INITIAL FIRE SAFETY INSPECTION REPORT

Green Life Knit Composite Ltd. (Extension)

Fire Safety Inspection Report

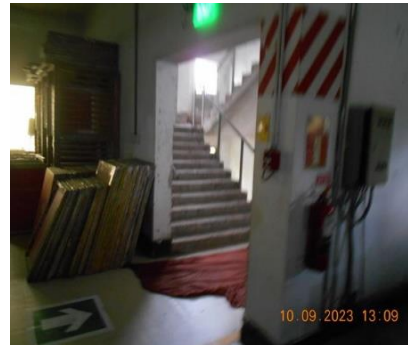
F-25	Fire Rated Construction.	3-Storied Printing & Embroidery building is steel construction which appears to be nonrated and were found in exposed condition Location: 3-Storied Printing & Embroidery building	The building is a steel structure which shall be type-I or II construction. So, provide require rating in the structural elements of the building. Consult with a qualified fire protection engineer. Follow BNBC 2006-Table 3.2.4, 3.1.9 and 3.3.1 as reference.	Within 6months
